Access Compliance Report

Public Rights-of-Way

Intersection ID: 28129	Main Street: OLIVIA_LN	Cross Street: ORCHID_PL	Location:	W
ADA ID: B93B0D3293FB	Ramp Type: BlendTrans2	Initial Pass/Fail: Fail	Overall Compliance: No	Severity Score: 35
Codes/Mitigation Info/Possible Solution		Field Measurements/Component Compliance

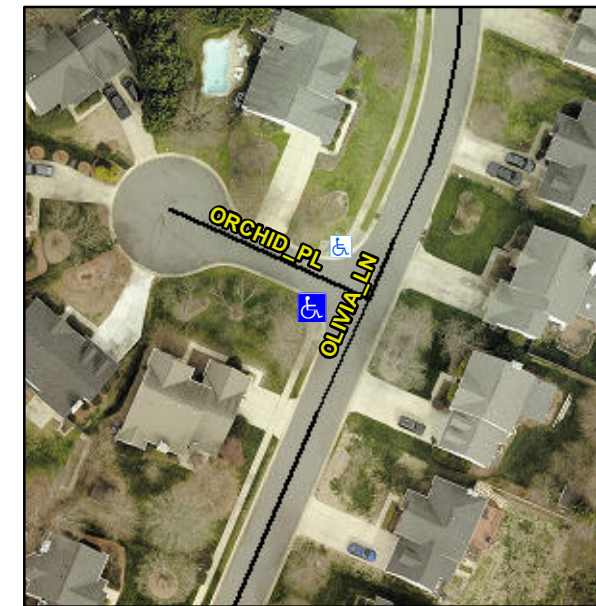
Not Found, R304.5.1

Compliance	Description	Data	Compliance	Description	Data
N/A	Ramp Length (in)	96.5	Yes	BlendTrans Slope (%)	4.2
No	Ramp Width (in)	26.0	Yes	BlendTrans XSlope (%)	1.1
N/A	Flare Type LT	N/A	N/A	Flare Type RT	N/A
N/A	Flare Slope LT (%)	N/A	N/A	Flare Slope RT (%)	N/A
N/A	Flare Traversable LT?	N/A	N/A	Flare Traversable RT?	N/A
N/A	Landing Length (in)	N/A	N/A	DWS Provided?	N/A
N/A	Landing Width (in)	N/A	N/A	DWS Contrast?	N/A
N/A	Landing Slope (%)	N/A	N/A	DWS Length (in)	N/A
N/A	Landing X Slope (%)	N/A	N/A	DWS Full Width?	N/A
N/A	Landing Curb? (Y/N)	N/A	N/A	DWS Offset (in)	N/A
N/A	Shared Landing?	N/A			
N/A	Gutter Ponding?	N/A	N/A	Gutter Slope (%)	N/A
N/A	Gutter Lip Ht (in)	N/A	N/A	Gutter X Slope (%)	N/A
N/A	Painted X Walk1?	No	N/A	Painted X Walk2?	No
	X Walk 1 Direction	To SE		X Walk 2 Direction	To NE
	X Walk 1 Width (in)	N/A		X Walk 2 Width (in)	N/A
	X Walk 1 Slope (%)	3.4		X Walk 2 Slope (%)	3.0
	X Walk 1 X Slope (%)	2.8		X Walk 2 X Slope (%)	2.3

N/A	Ramp inside XWalk1?	N/A	N/A	Ramp inside XWalk2?	N/A
	Road Slope (%)	0.3		Clear Space?	N/A
	Road X Slope (%)	5.1	N/A	Clear Space to XWalk (in)	N/A
N/A	Any Obstructions?	N/A	N/A	Storm Grate/Utility Hazard?	N/A
	Obstruction Type			Storm Grate/Utility Type	
		N/A			N/A
			Yes	Surface Condition? (G/P)	Good
			No	Curb Slope (%)	10.5

Remove & Replace Curb Ramp With Two New Directional Ramps or Equivalent.
